# ENVIRONMENTAL REVIEW TEAM REPORT

## PROPOSED BRENTWOOD APARTMENT COMPLEX THOMASTON, CONNECTICUT

**PROPOSED  
BRENTWOOD APARTMENT COMPLEX  
THOMASTON, CONNECTICUT  
SEPTEMBER, 1983**

# FIGURE 2 SITE PLAN

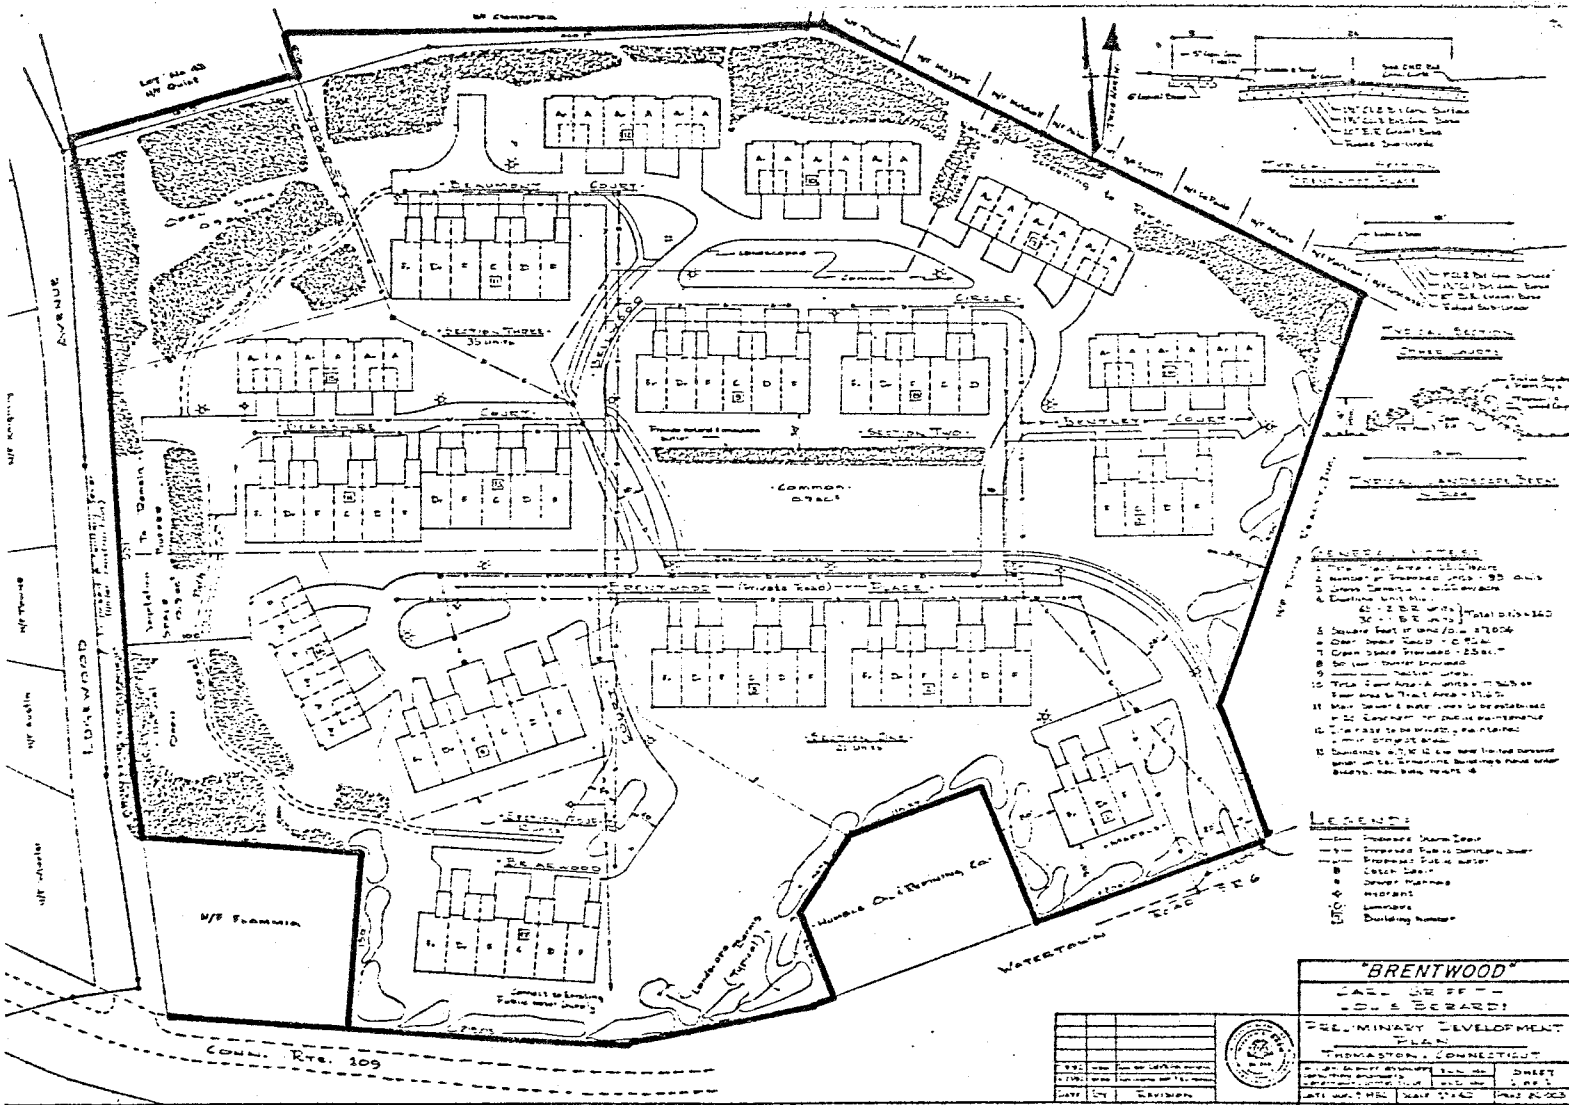
Although the proposed density is only 6 units per acre the over-all appearance of the plan appears crowded. There also seems to be an excessive amount of roadway, much of which has units on one side only. The areas abutting the highways are level and open, and the homes on Leigh Ave. were visible from most areas of the site, producing a sense of constraint and crowding. The PZC has required visual buffering in these areas.

One major problem is the lack of a second or emergency means of access for a development of this size. The State Department of Transportation sets the requirements for access to land from State roads. The State cannot deny access to property, but can set requirements, including redesign and reconstruction of state roads and intersections at the developer's expense. The ideal location for a second access would be at the western limit of the property on Route 109.

If this is not feasible, a second access should be provided on Route 6 far enough from the proposed one that both would not be blocked at the same time by an accident or other occurrence.

# FIGURE 4 WATERSHED MAP

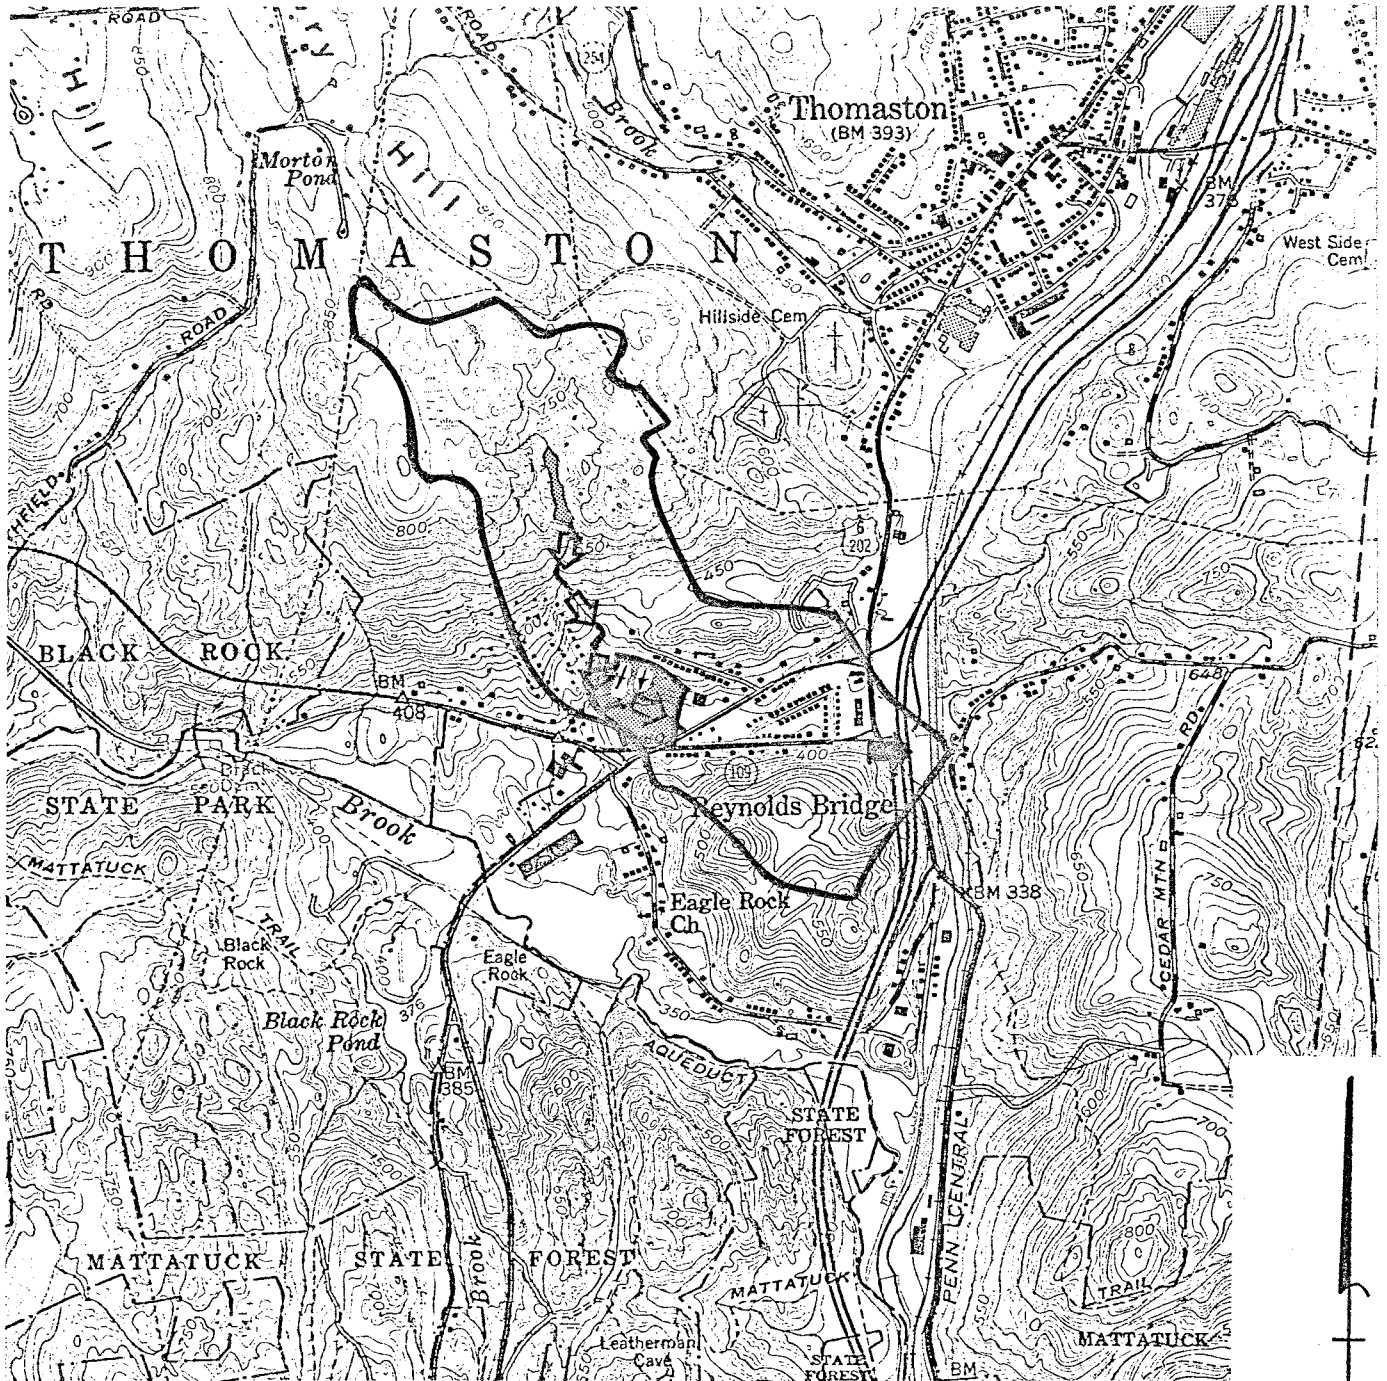
Development of the site will cause increases in the volume of runoff. These increases will be caused mainly by the creation of impervious surfaces (such as roofs, roads and parking areas) which are presently proposed to cover most of the site. Other contributing factors include the removal of vegetation, and compaction of soils on the site. The added runoff could cause increased overland and streamchannel erosion and it could increase the peak flood flows of the watercourse on the site. There could also be potential flooding at the culvert under Rte. 109 in the southeast portion of the site. These potential problems can be addressed by formulating and following an erosion and sediment control plan, particularly during the construction phase, and by establishing some type of runoff-control device such as a detention pond.

The table presented above indicates that the overall increases in runoff from the site could have a substantial potential for peak downstream flood flows, particularly at the culvert under Rte. 109, and for erosion. In order to avoid these potential problems, it is recommended that the developer(s) consider the use of a detention basin(s) or pond(s) that would prevent or at least reduce these increases. This type of facility may also be designed to serve a sediment retention function. If sediment does accumulate in the basin, it must be removed periodically in order to assure that the runoff-storage capacity of the pond is not seriously diminished. It should be noted that the culvert under Route 6 was observed to be partly blocked with sand and debris the day of the Team's field review. This blockage restricts the capacity of the culvert to handle stormwater flows, and should be removed. As mentioned earlier, an erosion and sediment control plan should be formulated and implemented during the construction phase of the proposed project.

Serious consideration should be given to leaving open the stream channel on site and riprapping the sides and bottom to protect from erosive velocities. There would be some recharging of water to the ground if the stream was left open and not put into a pipe. Should the channel be left open, however, there would be a need to consider its proper maintenance if high density housing is approved for the site (e.g. repair of riprap, keeping trash out, etc).

# FIGURE 5 SOILS MAP

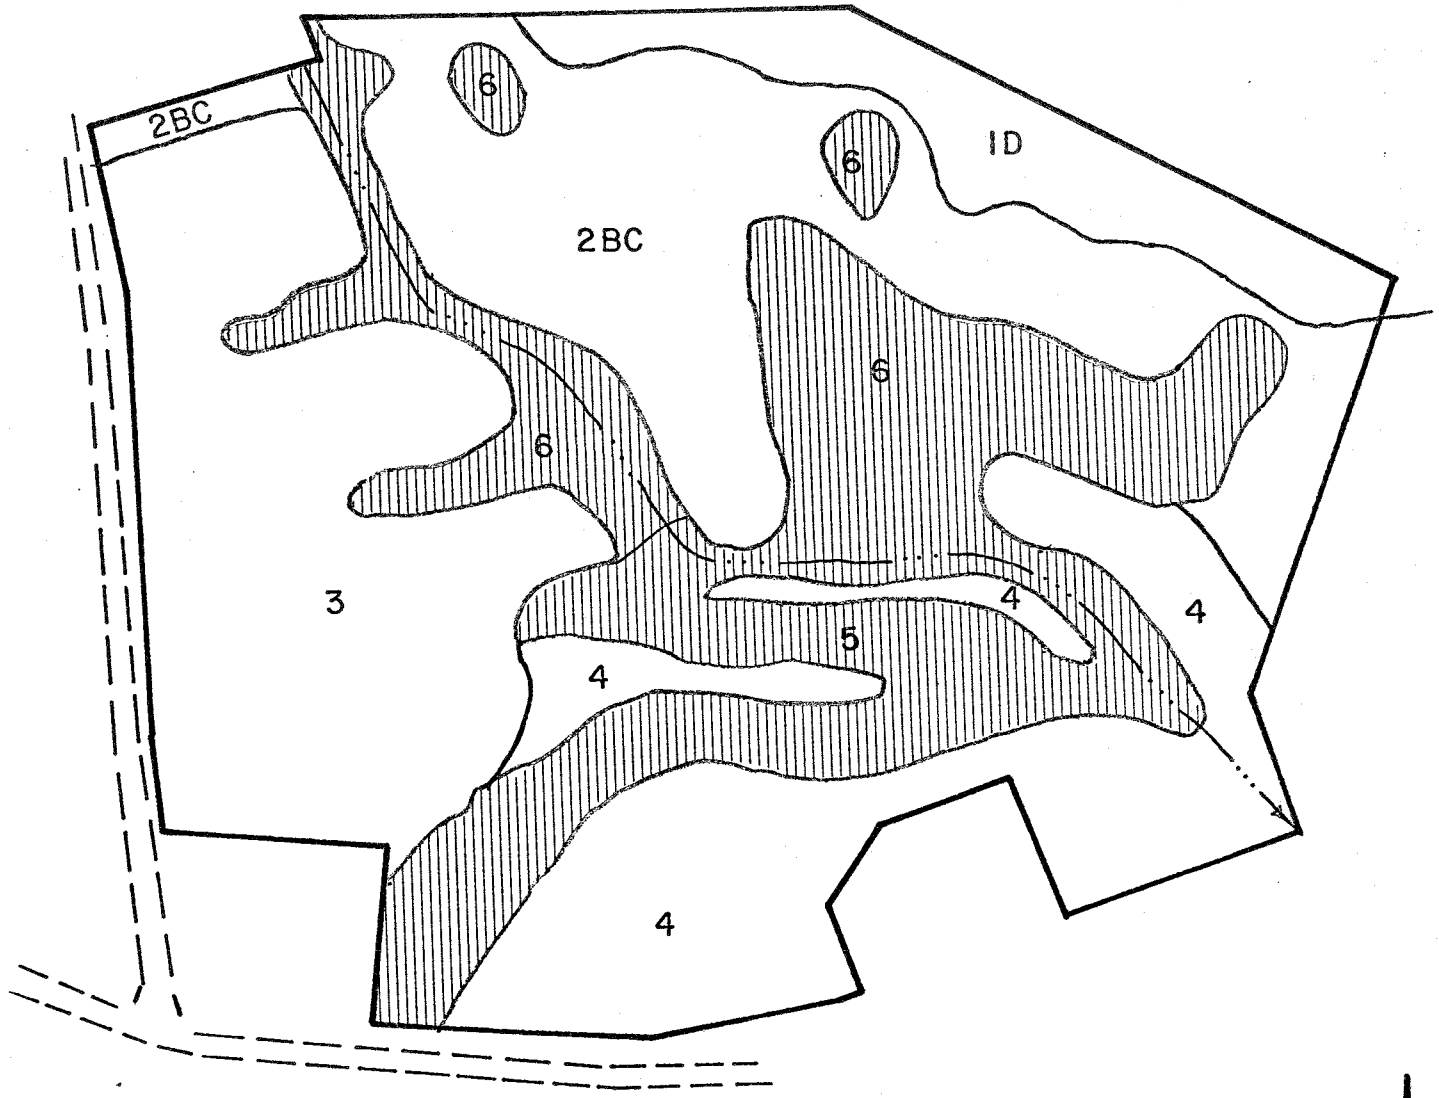
The subject site has been modified by extensive cuts and fills, with two areas dominated by poorly drained or very poorly drained soils. Area 5 (see Soils Map) is depressional and collects and stores water from the property. The significant area of Raynham and Birdsall soils present\*, and the slow permeability of these soils, indicate this area allows little ground water recharge. This however, may not be the case along the stream corridor itself. Area 6 has been cut and filled as well. The large area of unit 6 south of units 2 BC and 1 D is slightly depressional and appears to be accumulating water from various springs at the base of the steeper 2 BC and 1 D units. To retain the layout and location of the proposed housing units, both areas 5 and 6 would need to be filled in. This would remove the natural storm water retention function of these areas. This negative impact could probably be overcome, however, by the installation of artificial retention basins on the site.

The area designated as "open space" bordering Edgewood Avenue, is dominantly moderately well drained, and is thus more suitable to residential units than areas 5 or 6. Leveling, spot drainage and the addition of topsoil would be necessary for lawns, landscaping and playing fields on the open space areas.
